RE: Additional Remedial Action Plan (RAP) Information
Former Comedy Club Café
615 E. Brady Street
Milwaukee, Wisconsin 53202
UEC Project No. 17028.5
BRRTS No. 02-41-553001

In a July 3, 2018 letter, Nancy Ryan of the Wisconsin Department of Natural Resources (WDNR) requested additional information from United Engineering Consultants, Inc. (United) prior to approval of the Revised Remedial Action Plan (RAP) report dated May 23, 2018 submitted to the WDNR on May 24, 2018. The following paragraphs discuss the six (6) items outlined in the WDNR correspondence. A summary of each WDNR request is italicized.

Figure 2: Site Plan Map

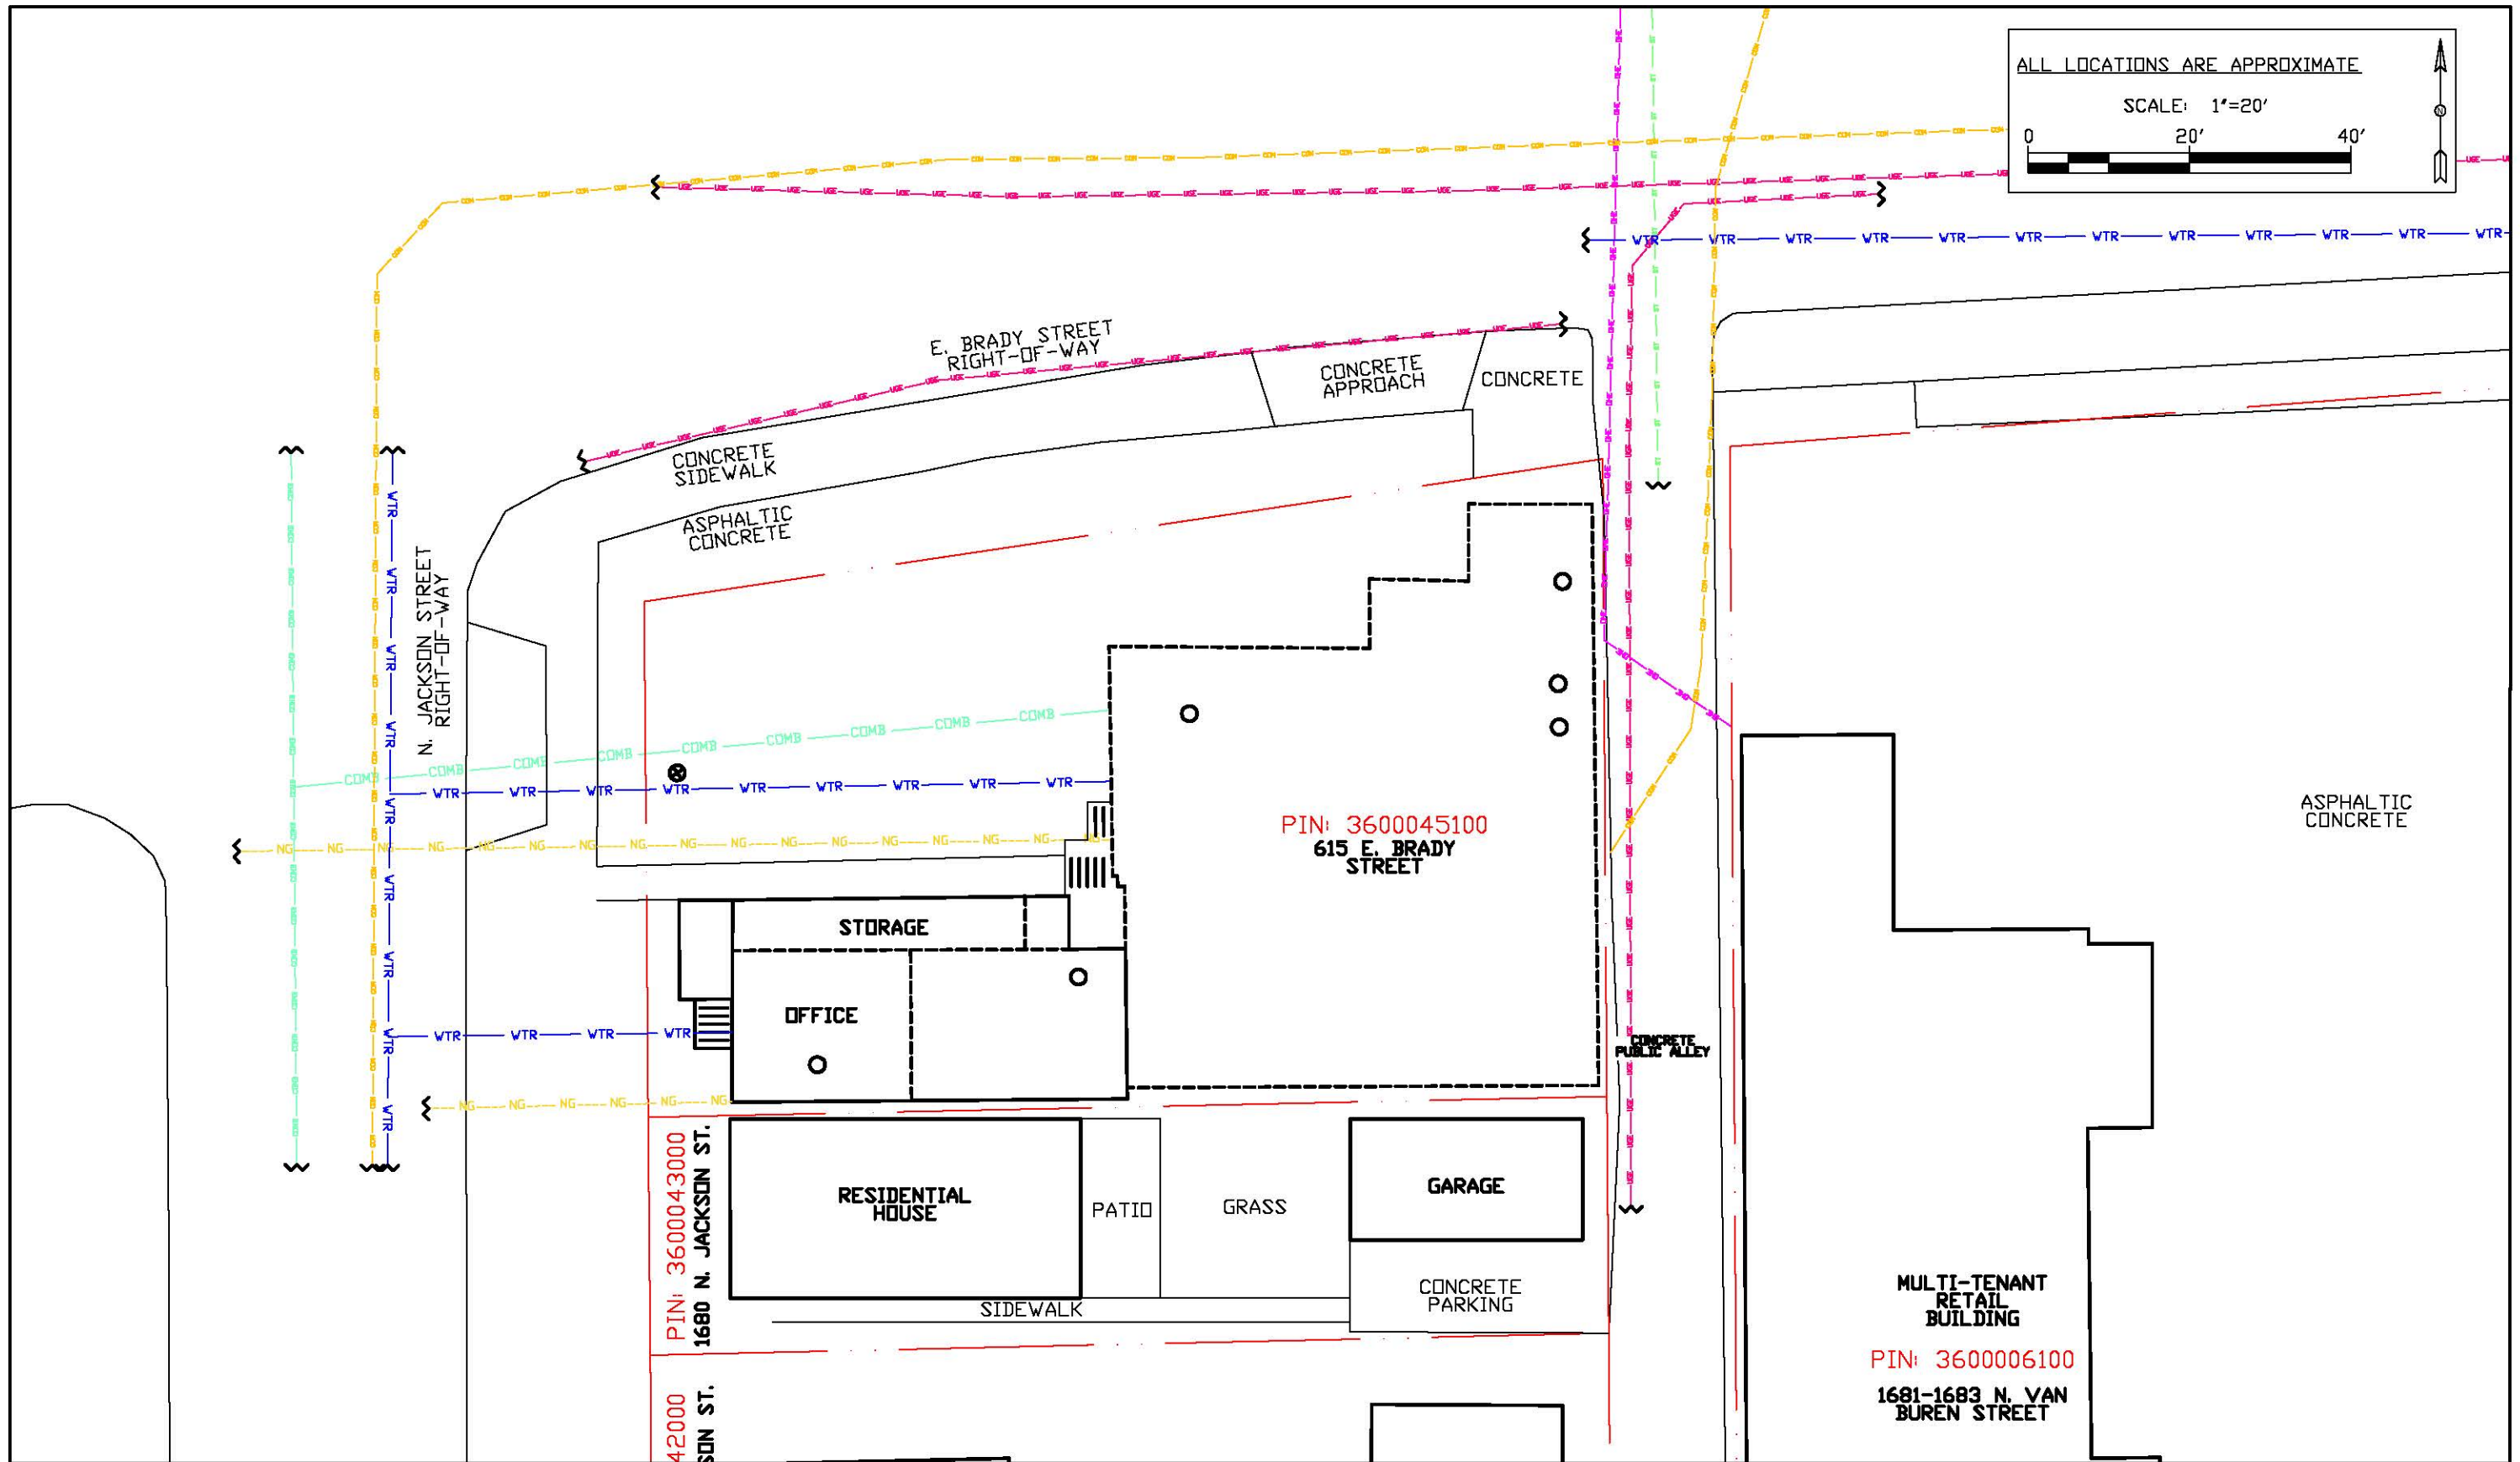
The WDNR requested additional detail regarding the abandonment and replacement of underground utilities at the subject property. Specifically, the WDNR requested the submittal of a site map indicating the former and current location of the potable water and natural gas service and a discussion of their abandonment and installation procedures. In addition, a discussion of the combined sanitary and storm sewer upgrades including the catch basin located along the western property line was requested. The WDNR also requested a description of any soil management activities related to the removal and replacement of the underground utilities including soil disposal documentation, if applicable.

The underground potable water and natural gas laterals which extended to the former Comedy Club Café building at 615 E. Brady Street from mains in the N. Jackson Street right-of-way were disconnected at the western elevation of the existing structure and abandoned in-place. No spoil was generated during the abandonment of these utilities.

New potable water and natural gas laterals were extended in a common trench from the N. Jackson Street mains to the northwest corner of the structure at 1684 N. Jackson Street. The excavated soil was transported to Waste Management's Metro RDF in Franklin, Wisconsin for proper off-site disposal under profile V128792WI. The combined sanitary and storm sewer was re-fitted with Polyvinyl Chloride (PVC) piping installed from the building to the main in N. Jackson Street. Minimal to no spoil was generated during the combined sewer upgrade.

The brick catch basin located at the southwest corner of the 615 E. Brady Street parcel was removed. Visible observations performed during its removal indicated it was not connected to the municipal sewer system or the on-site combined sanitary and storm sewer lateral. The material removed immediately adjacent to the abandoned brick catch basin consisted of gravel which was transported to Metro RDF for disposal under profile V128792WI.

The former location of these underground utilities is indicated in the attached Figure 2: Site Plan Map. Their current location is indicated on the attached Figure 17: Building Addition, Patio, Cooler and Dumpster Corral Location Map.

Figure 18: Commerical Building Excavation Limits Map

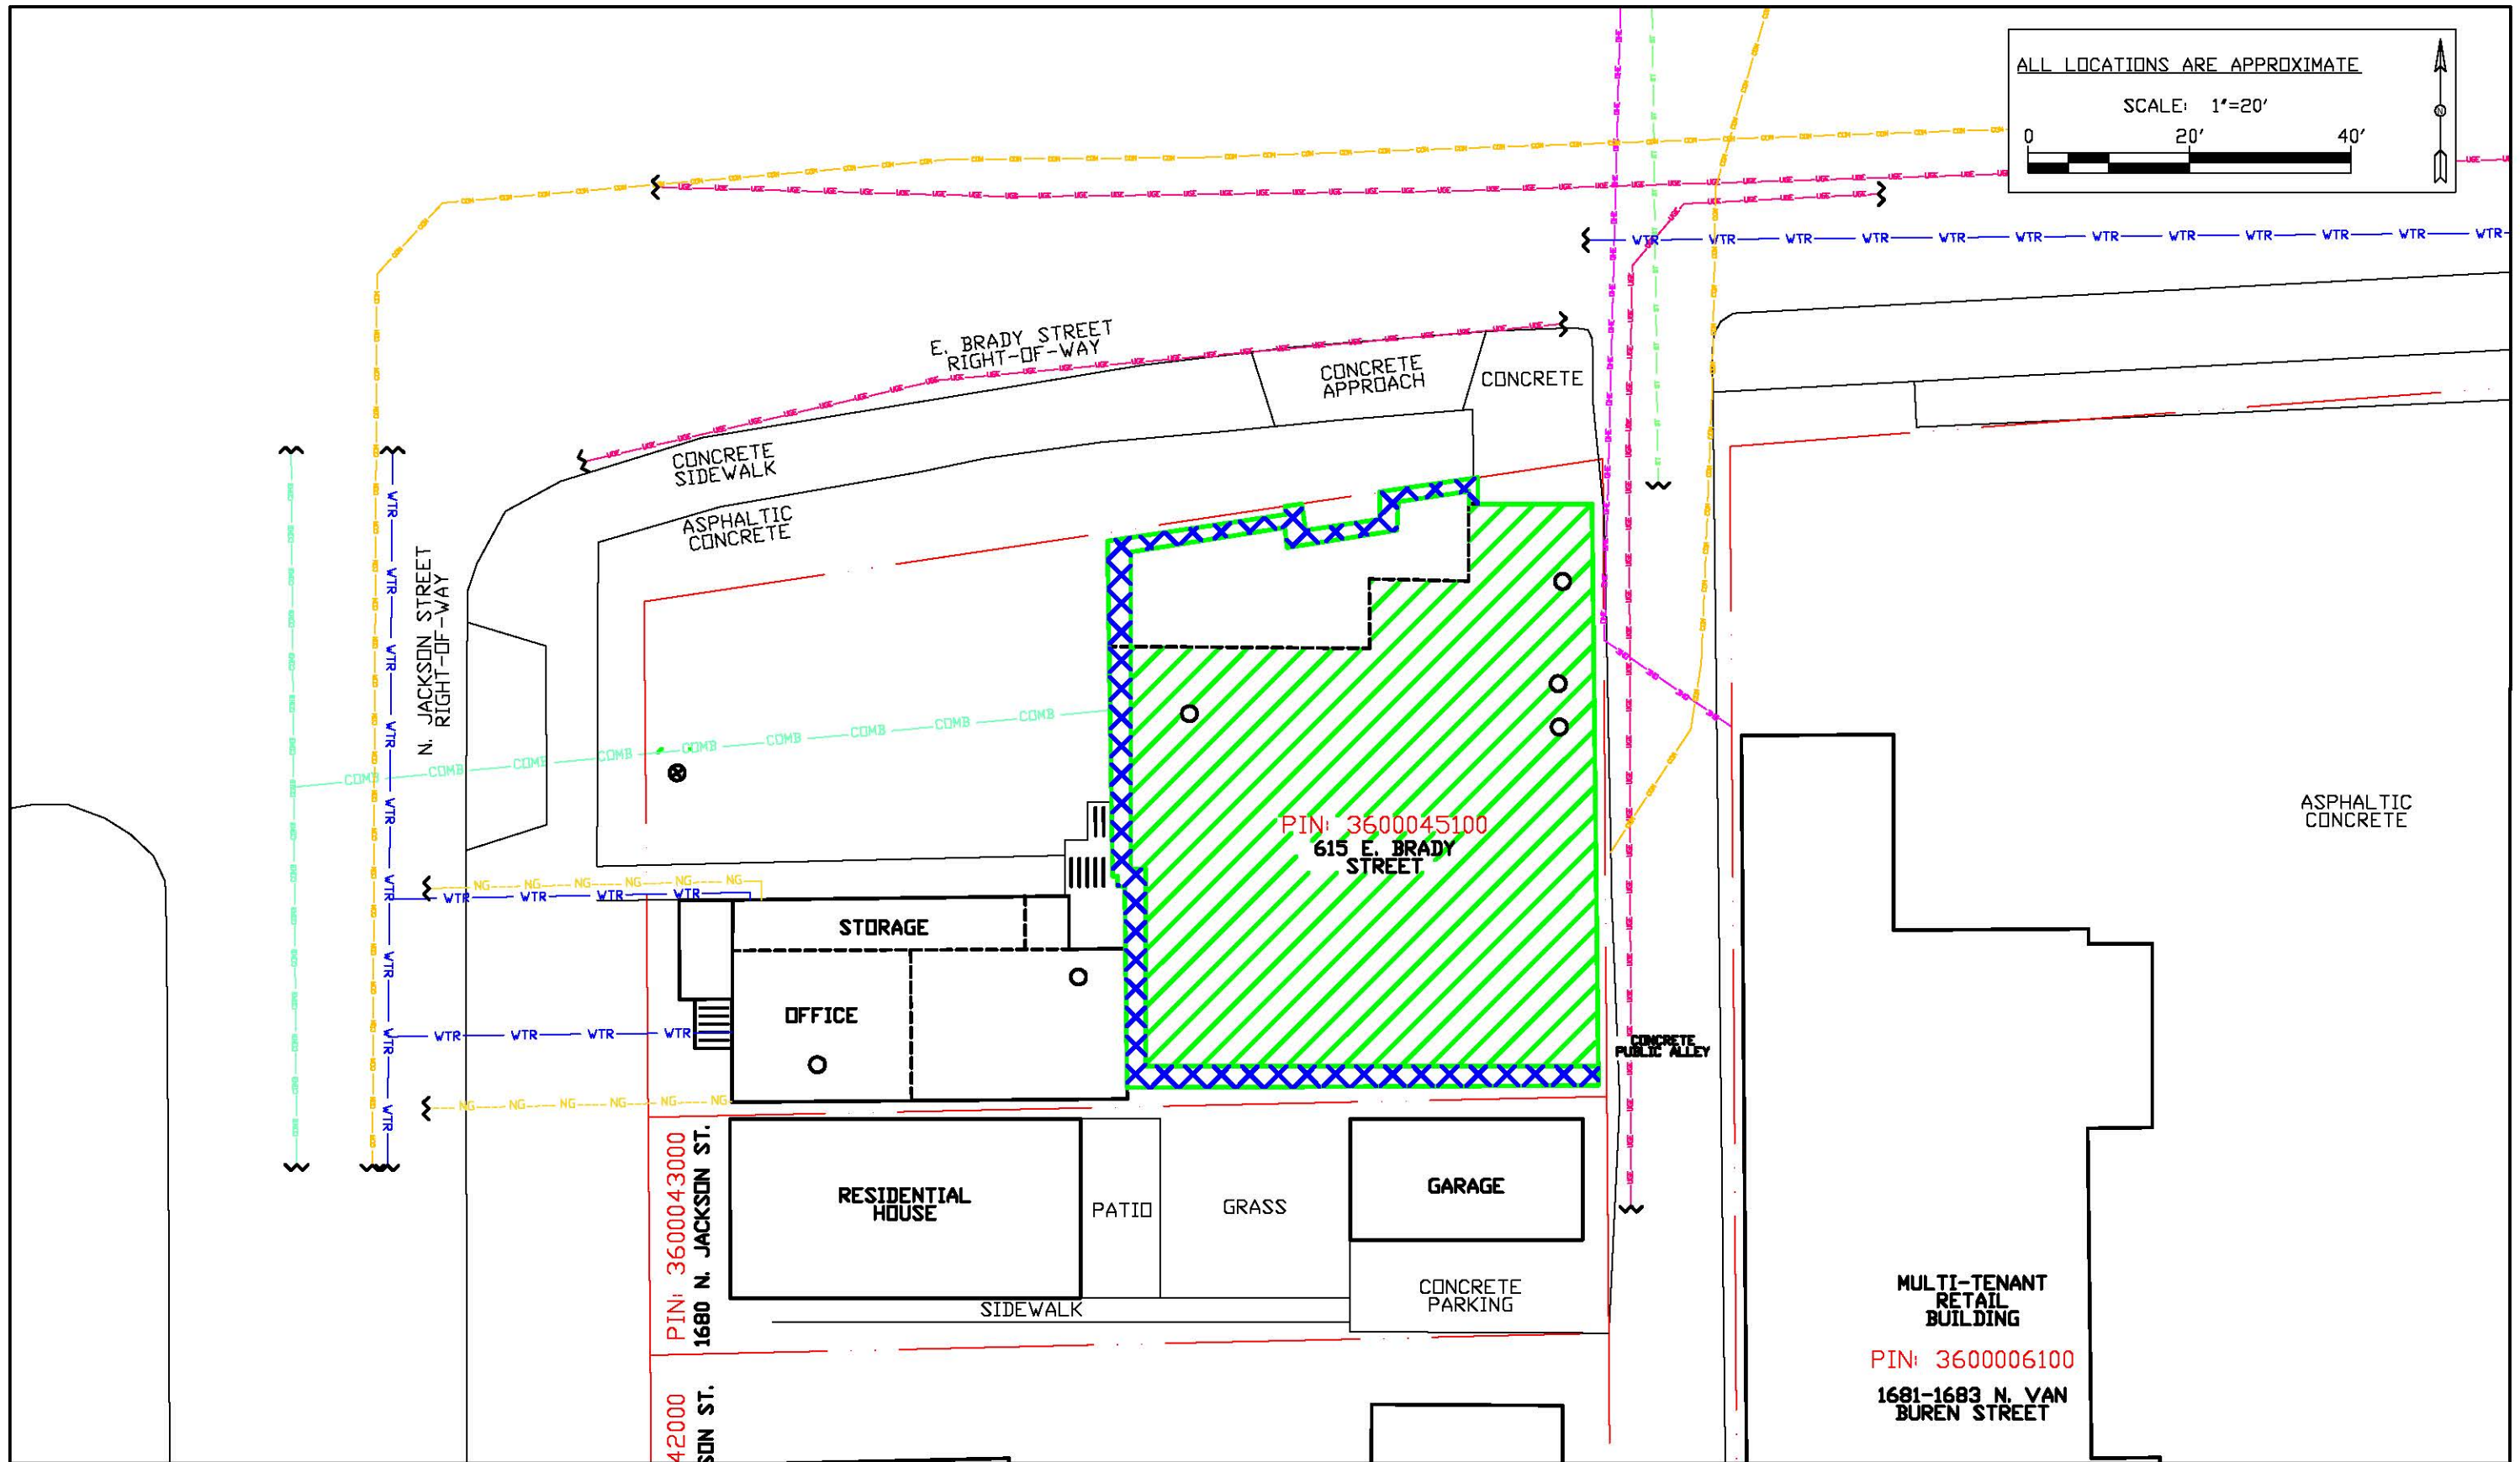
The WDNR requested a revised Figure 18 – Remedial Action Map to include the approximate excavation depths for the addition foundation and the foundation reinforcement of the southern and western perimeter building wall footings. The WDNR also requested a description of the soil removed from around the former catch basin located along the western property line and to provide any soil characterization and disposal documentation. In addition, the WDNR requested submittal of disposal documentation for all excavated soil.

The excavations for the northern building addition, the reinforcement of the western wall footing and the removal and replacement of the southern wall footing for the 615 E. Brady Street structure extended approximately five (5) feet below the current concrete floor elevation (See attached Revised Figure 18: Commercial Building Excavation Limits Map) The backfill soil removed adjacent to the western and southern wall footings predominantly consisted of gravel. The soil excavated for the northern building addition consisted of brown clayey silt to silty clay with varying amounts of sand and gravel. The material removed immediately adjacent to the abandoned brick catch basin consisted of gravel. These materials were transported to Metro RDF for off-site disposal under Profile V128792WI.
